CITY OF TORRANCE, CALIFORNIA

**ADDENDUM NO. 2
Issued: September 23, 2010**

**PROPOSAL, SPECIFICATIONS, BOND AND
AFFIDAVIT FOR THE CONSTRUCTION
OF
WALTERIA RESERVOIR SLOPE STABILITY PROJECT, C.I.P. No. I-95
B2010-17**

10. Refer to PLAN SHEET WP-280, Sheet 10 of 12, Note 1 and ADDENDUM No. 1 – Item No. 5.

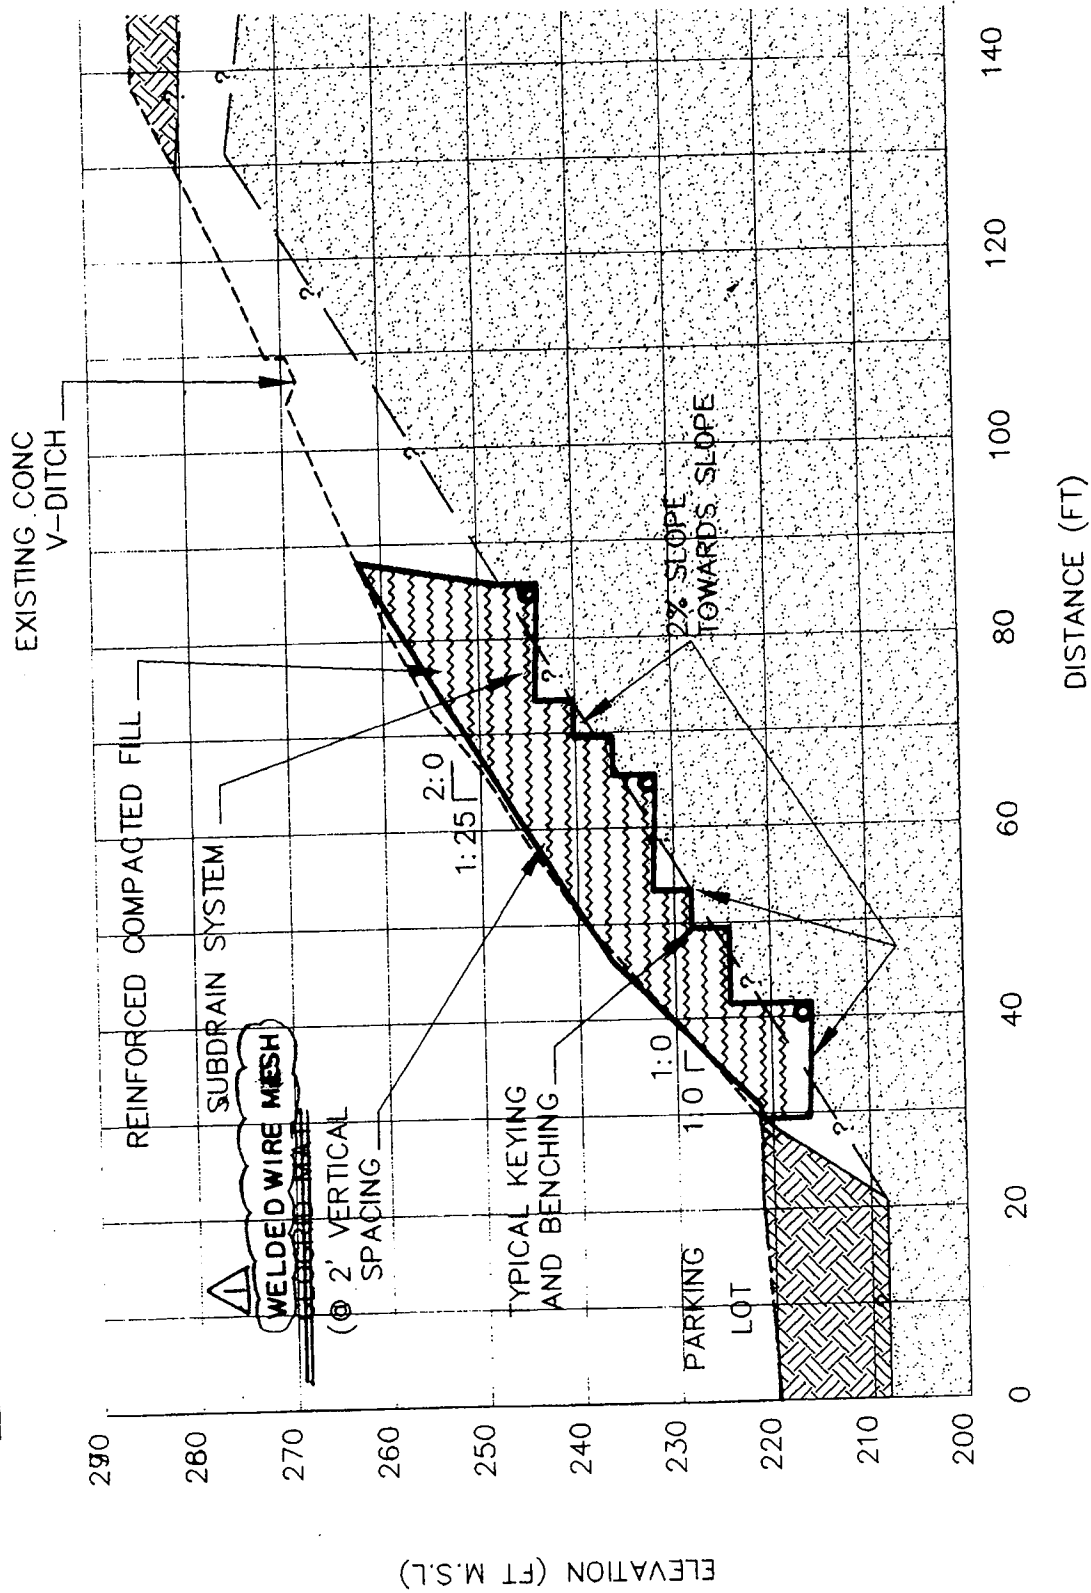
The Geo-technical Report referenced in the note and provided as Appendix VIII of the Specifications in Addendum No. 1 is hereby revised to include pages 9 – 14, is presented herein as Attachment No. 3.

SHEET 8 OF 12 SHEETS.

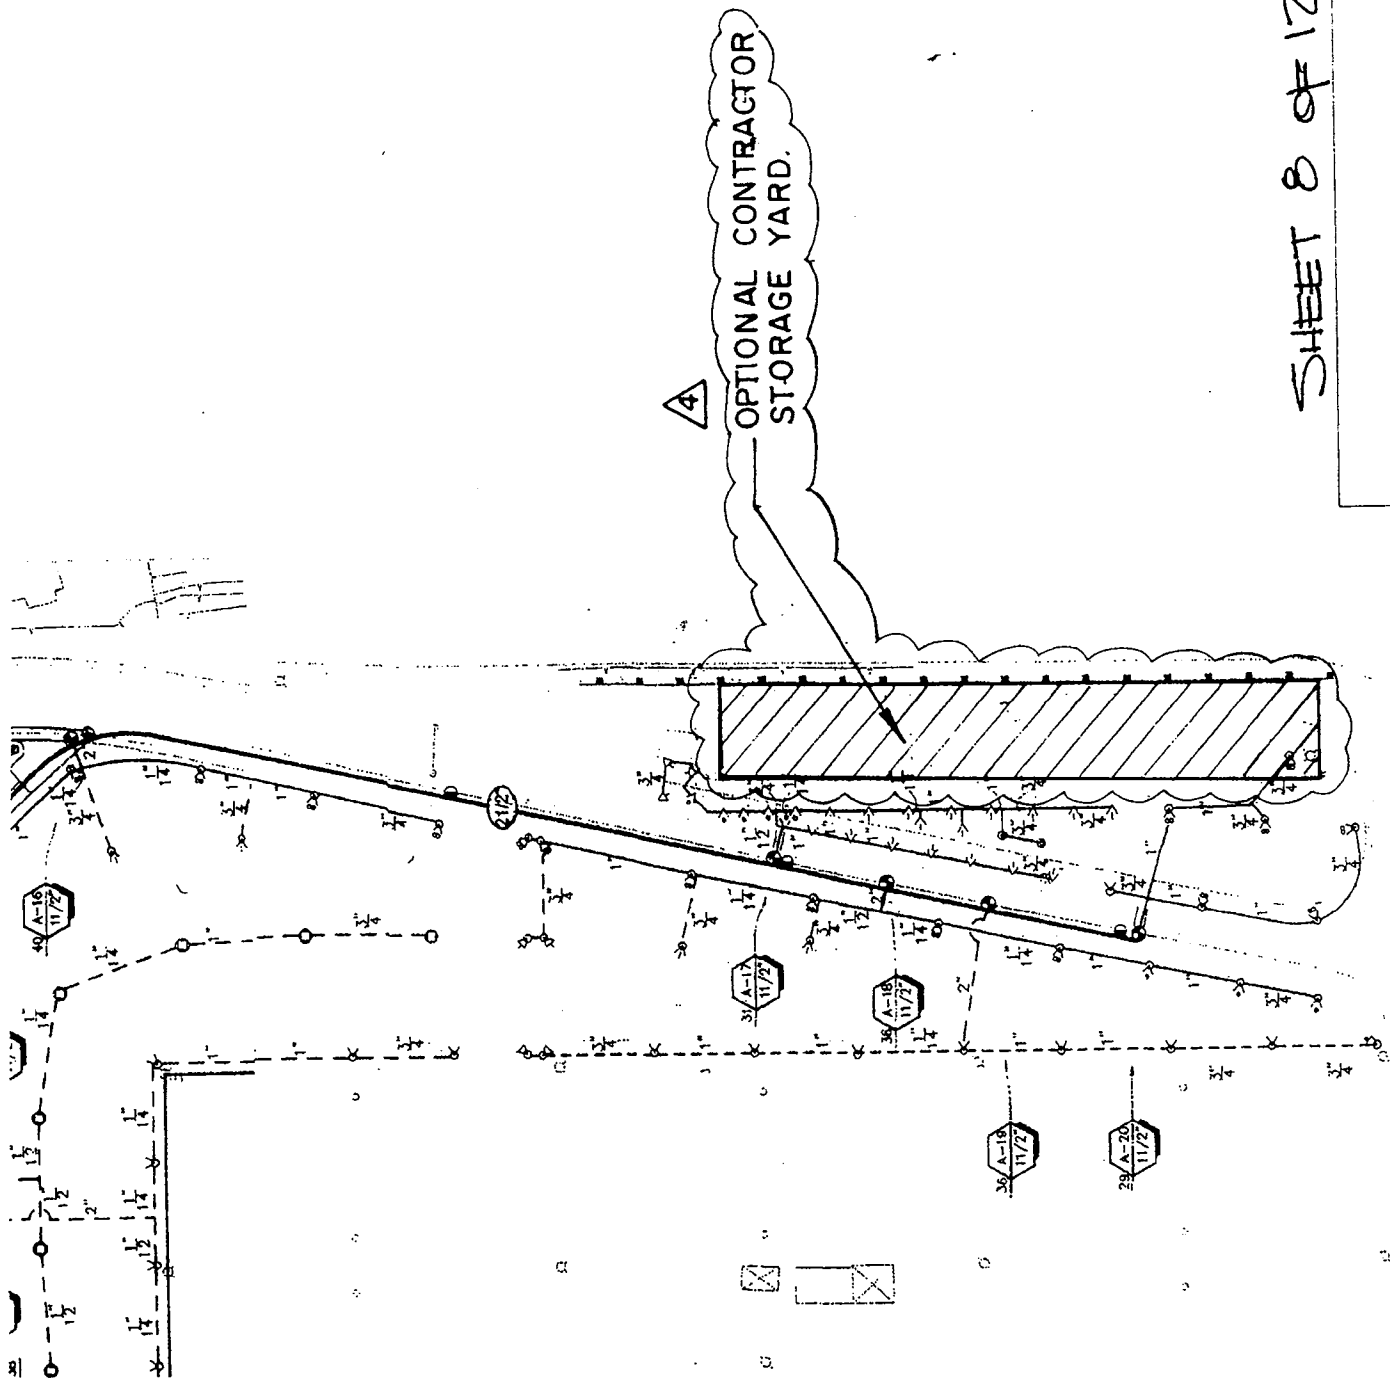
12. Refer to PLAN SHEET WP-280, Sheet 8 of 12.

The site plan is revised below to show the location of the optional Contractor's storage yard:
